# SERVICE BULLETIN INDEX

LOTUS CARS Ltd NORWICH NORFOLK NR92W

## 1974 SERIES (FEDERAL)

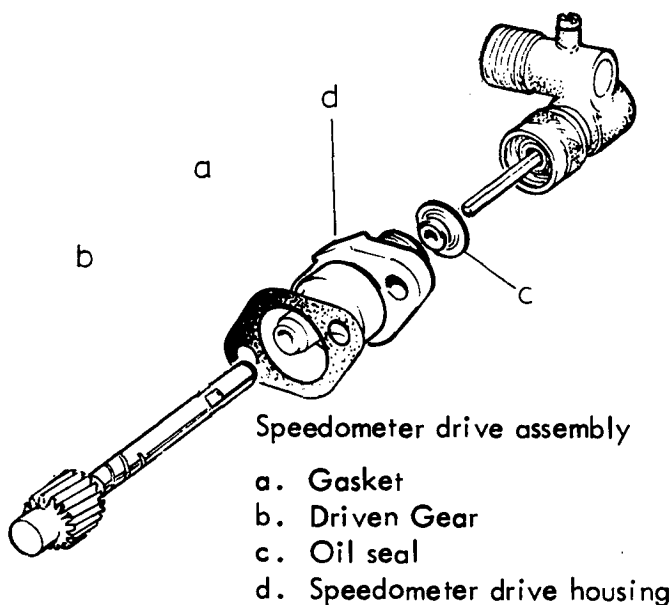
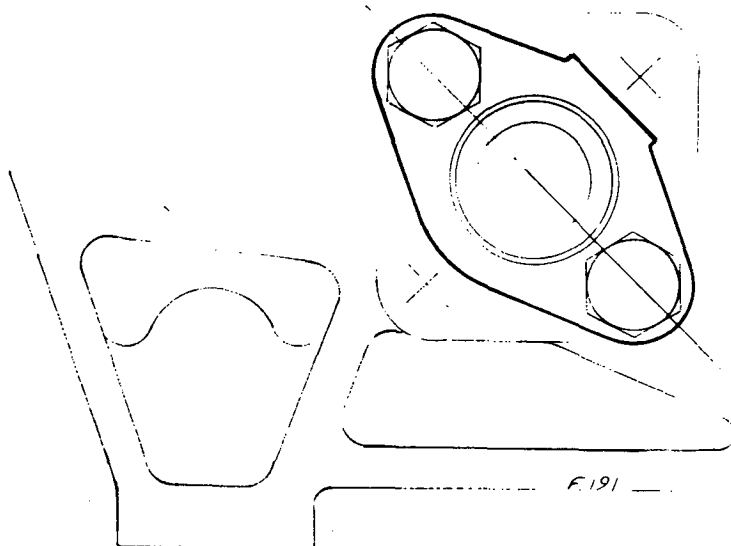
Title: Speedo Drive Spindle Endfloat.

Reason: To avoid the possibility of the Speedo Drive Spindle seizing in the speedometer Drive Housing.

- c) Fit additional gaskets (See A on illustration) to achieve correct spindle endfloat.
- d) Apply 'Silastic' to both sides of the speedometer drive housing gasket(s) and place the gasket(s) on the speedometer drive housing.

- e) Using the illustration as a guide, assemble the speedometer drive assembly in the following order:
  1. Gasket on speedometer drive housing.
  2. Place driven gear into speedometer drive housing.

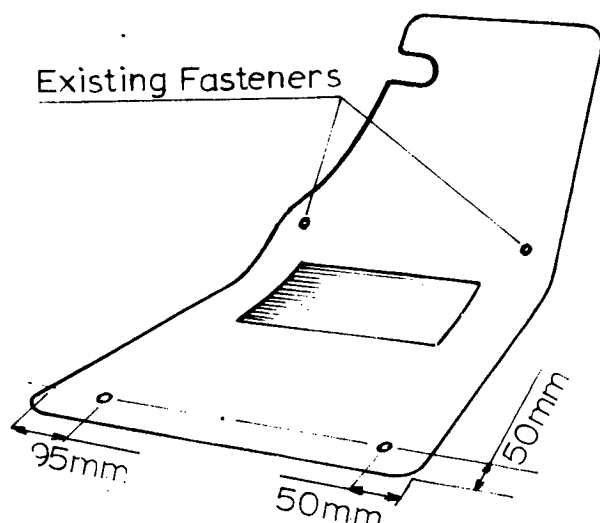
Title: Additional Carpet Fasteners to Front Footmats

Reason: To provide more fixings for passenger's and driver's footmats.

Action: Using the illustration as a guide, fit two additional carpet fixings to each front footmat and the car floor. Drill an appropriate diameter hole and secure each socket to the floor in the following order: socket, penny washer, secure them with a spire screw and a spire nut on the underside of the car floor. Seal each screw with underseal to prevent the ingress of water.

Fig. 1

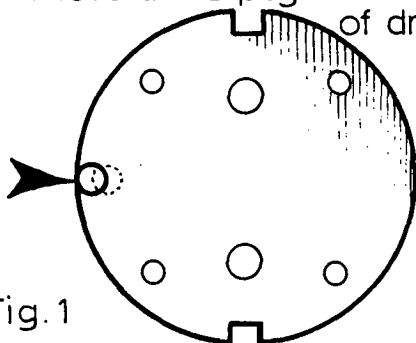
6. Remove the drive peg from the drive plate by drilling it out. Re-position the drive peg to the extreme edge of the drive plate as shown on illustration Fig. 1. Braze the drive peg on to the drive plate and fill the existing hole (where peg was removed from) at the same time.

Move drive peg to extreme edge of drive plate.

Fig. 2

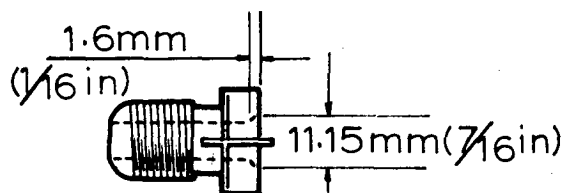
8. Grind .8 mm (1/32 in.) min. off the wiper rack head, see Fig. 2.
9. Counterbore the ferrule 11.15 mm (7/16 in.) diameter to a depth of 1.6 mm (1/16 in.) see Fig. 3.

Grind down rack head.

Replacement of one section of the bright trim

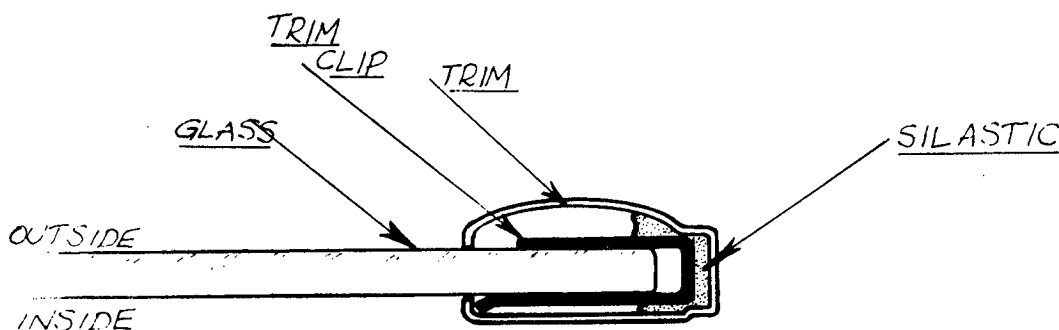
When replacing one section of the bright trim surround, it is usually necessary, to replace the corner trim caps and the trim retaining clips (4 clips for the upper or lower and 2 clips for each side trim section).

1. Mark the position of the damaged trim section on the glass, using some tape or a "magic" marker.
2. Remove the corner trim cap from each end of the damaged trim section.
3. Release the trim from the glass on both sides.  
Note that the trim on the inside of the tailgate glass has to be lifted over the trim retaining clips, see illustration, and remove the damaged trim section.
